SITE AS-BUILT LIMITED SITE PLAN MODIFICATION
76 GROVE STREET (LOT 3)
FRANKLIN, MASSACHUSETTS

In response to the applicant's submission of a final Form H for the subject project, we reviewed the final as-built plan, the approved Limited Site Plan Modification from 2008, and performed a site visit. We offer the following comments:

Observed Construction: BETA arrived on-site to perform a conformance observation in conjunction with the Applicant’s for acceptance Form H – Certificate of Completion. The as-built plan, dated June 8, 2022, and Form H were provided by email. BETA walked the site and noted that the project has been constructed in general accordance with the approved plans with the following exceptions/notations:

Date: 7/20/2022 Job No.: 4831-106
To: Mr. Gregory Rondeau, Chairman
Cc:
From: BETA Group, Inc.
Subject: Washington Street (Franklin Flex Space) Field Modification

RED-LINE AS-BUILT GRADING, DRAINAGE AND UTILITIES PLAN

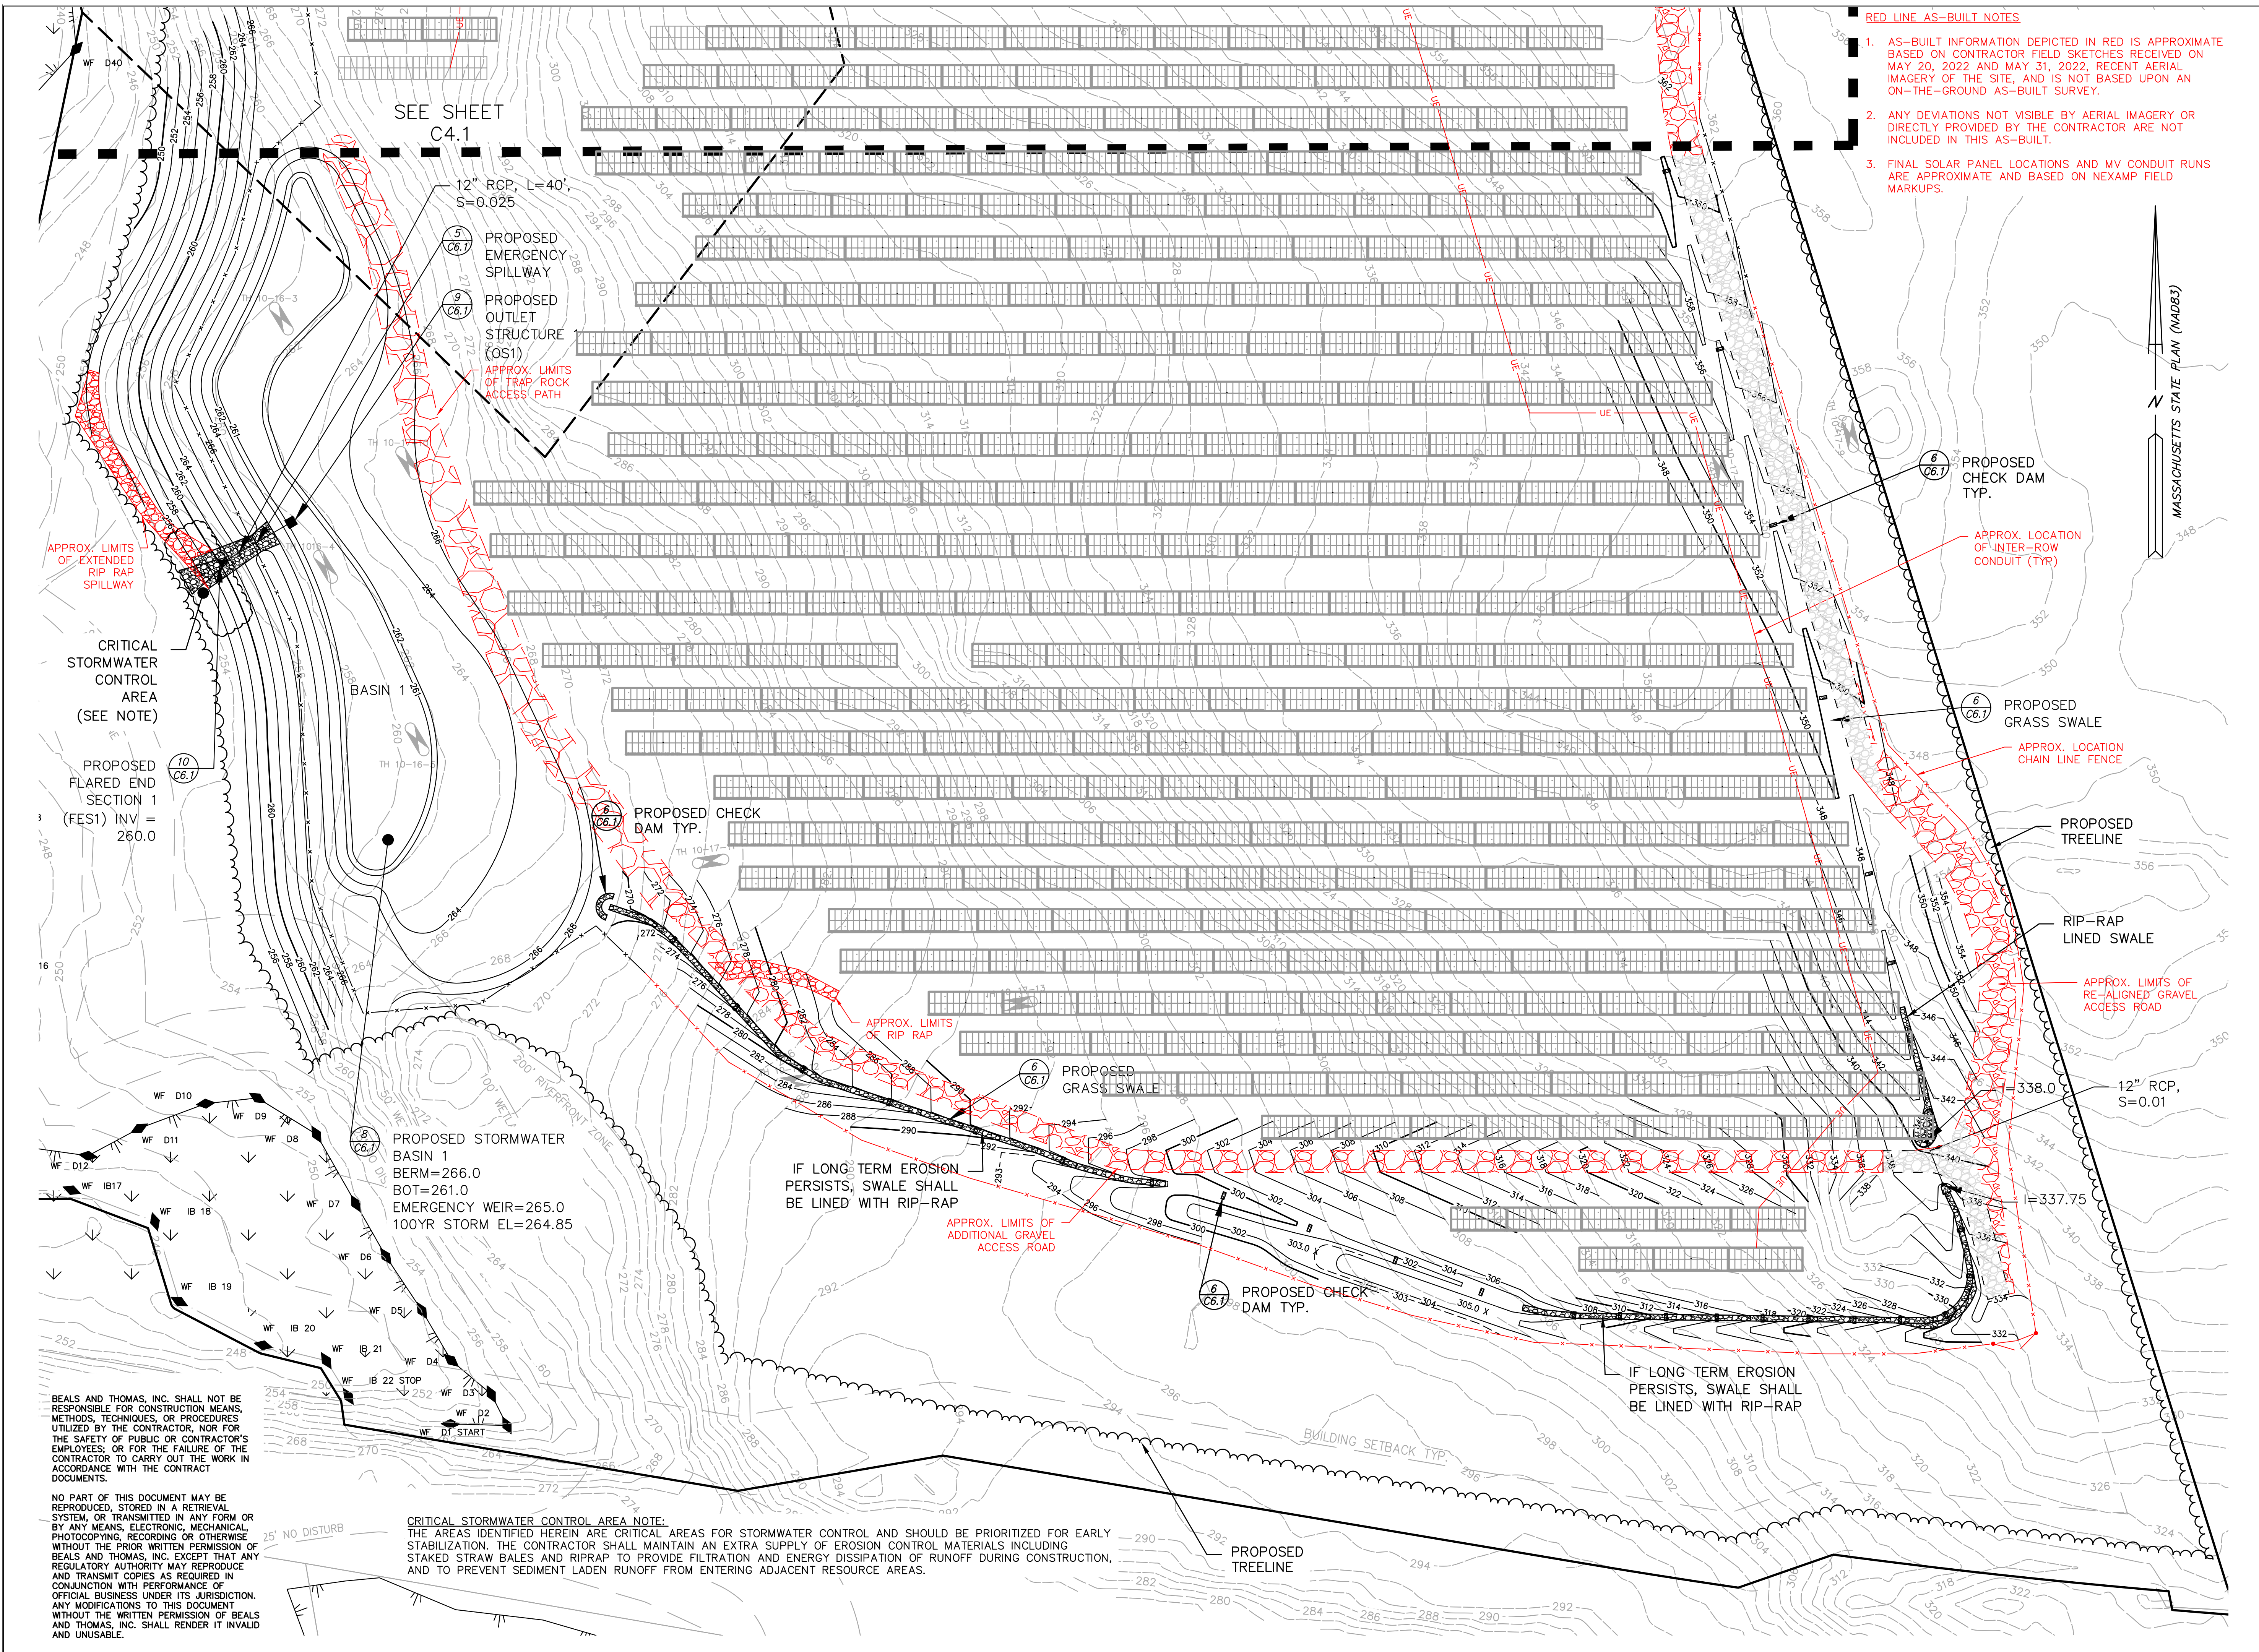
- Red-line notations on the as-built plans including the addition of stump grinding berms for stormwater dissipation, addition of a rip rap swale on the interior of the array area, minor realignments of the gravel access road, and the extension of the gravel access road along the southerly and westerly sides of the arrays. BETA notes these revisions provide improved site stability and adequate access to perform general site maintenance.

- The provided as-built is not based upon field survey. BETA defers to the preference of the Board to provide a fully surveyed plan. At a minimum, BETA recommends for field survey to be performed in the areas of the stormwater basins so storage volumes and inverts can be confirmed.

- The array areas are well stabilized and typically have good vegetative coverage throughout. There are several small areas with limited coverage; however, BETA estimates these represent a very small percentage of the site and remain stabilized.
- Sandbags need to be removed from Infiltration Basin 1 outlet control structure
- Infiltration Basin 1 needs to be maintained to remove wetland vegetation and accumulated silt. BETA notes the infiltrative capacity of the soils was likely impacted by siltation in the early stages of the project when the site was unstabilized. Following removal of vegetation and silt the underlying soils should be scarified and the surface restored with loam and seed in accordance with the Approved Plans.

**SITE PLAN MODIFICATION
SITE LAYOUT PLAN**
275 WASHINGTON STREET
FRANKLIN, MASSACHUSETTS
PREPARED FOR
FRANKLIN FLEX SPACE, LLC
13 CLOVELLY ROAD
WELLESLEY, MASSACHUSETTS
JULY 14, 2022
SCALE: 1" = 40'

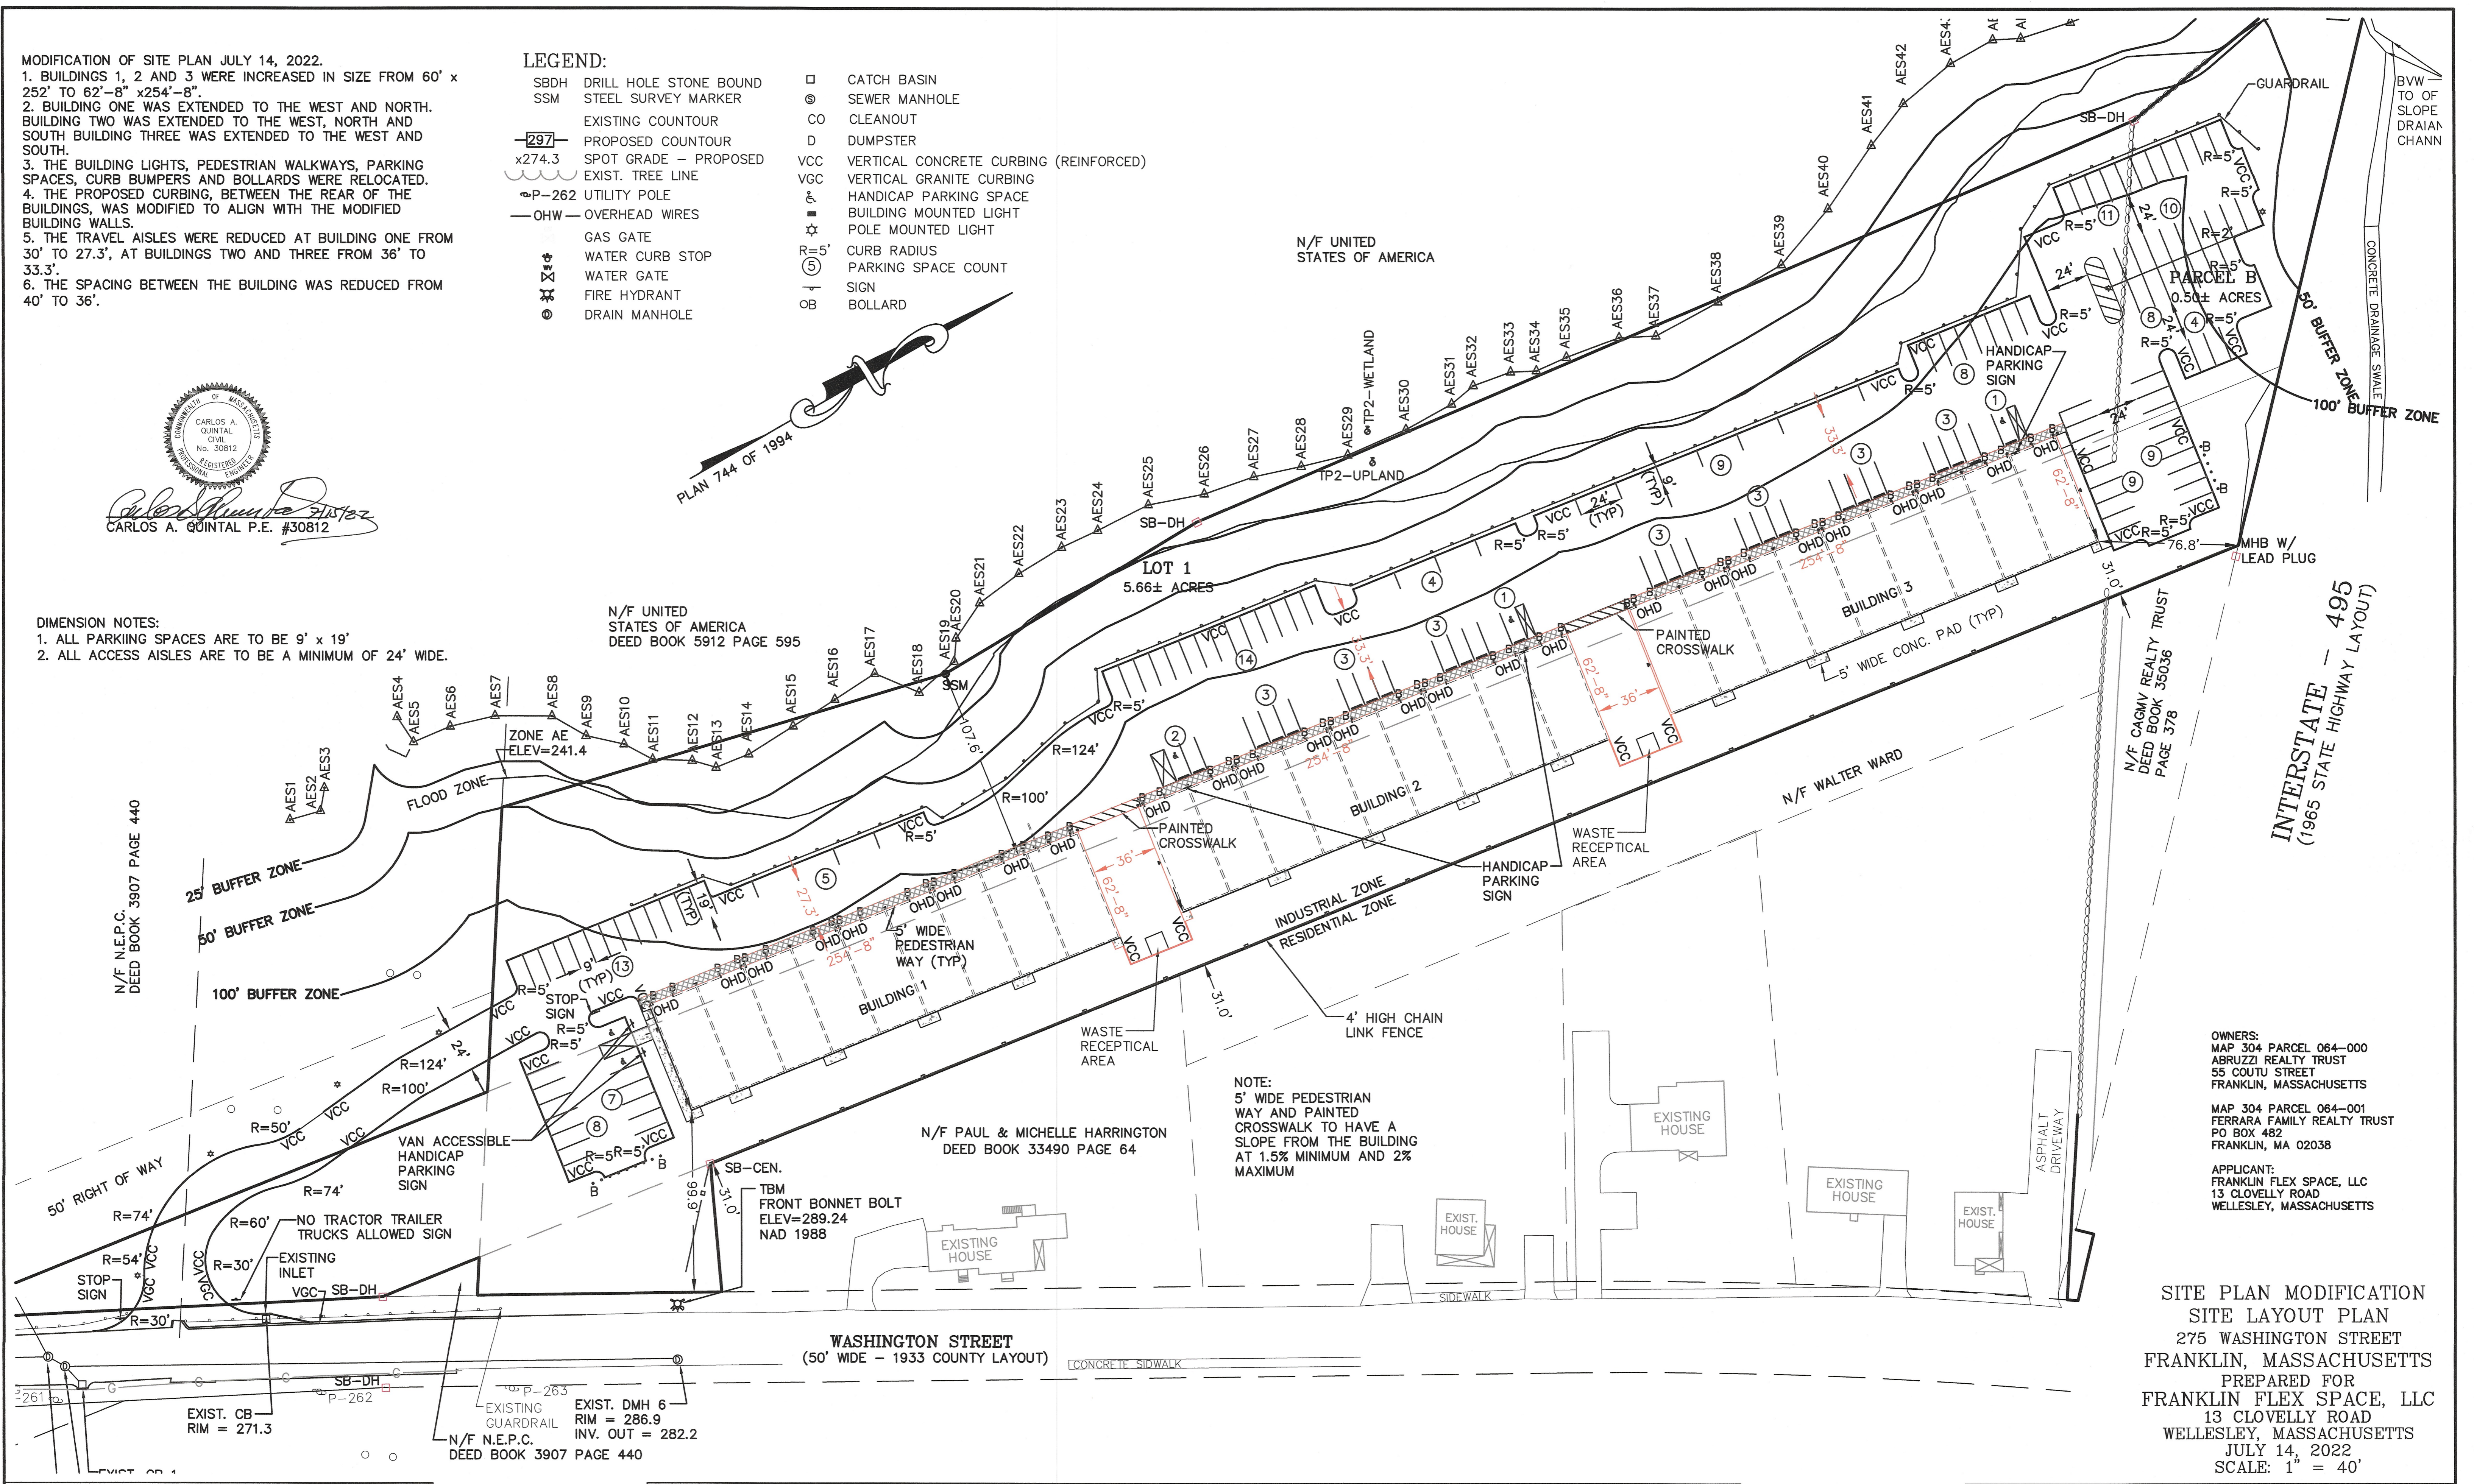
- The property line setback of 31.0' from the Residential Zone to the east will be maintained. The southeast corner of building no. 1 closest to Washington Street and the northeast corner of building no. 3 closest to Route 495 will also be maintained. The proposed paved areas located between the buildings will be reduced in width from 40' to 36' to compensate for the increased building width. Thus, the building setbacks from the approved plans to the Residential Zone to the east, Washington Street to the south and Route 495 to the north will remain the same.

- G2. *Access between the building will continue to be wide enough for waste disposal pick up based upon the turning template from the design plans.*
- G3. *The access lane along the front of the buildings although reduced in width, will remain wide enough to accommodate two-way traffic, and allow access to the overhead doors along the front of the buildings.*

- G4. *The Parking Calculations from Sheet 3 of the approved drawings will be changed by the increase in the footprint size. BETA recommends that a revised Parking Summary be included on the plan.*

1. BUILDINGS 1, 2 AND 3 WERE INCREASED IN SIZE FROM 60' x 252' TO 62'-8" x 254'-8".
2. BUILDING ONE WAS EXTENDED TO THE WEST AND NORTH. BUILDING TWO WAS EXTENDED TO THE WEST, NORTH AND SOUTH BUILDING THREE WAS EXTENDED TO THE WEST AND SOUTH.
3. THE BUILDING LIGHTS, PEDESTRIAN WALKWAYS, PARKING SPACES, CURB BUMPERS AND BOLLARDS WERE RELOCATED.
4. THE PROPOSED CURBING, BETWEEN THE REAR OF THE BUILDINGS, WAS MODIFIED TO ALIGN WITH THE MODIFIED BUILDING WALLS.
5. THE TRAVEL AISLES WERE REDUCED AT BUILDING ONE FROM 30' TO 27.3', AT BUILDINGS TWO AND THREE FROM 36' TO 33.3'.
6. THE SPACING BETWEEN THE BUILDING WAS REDUCED FROM 40' TO 36'.
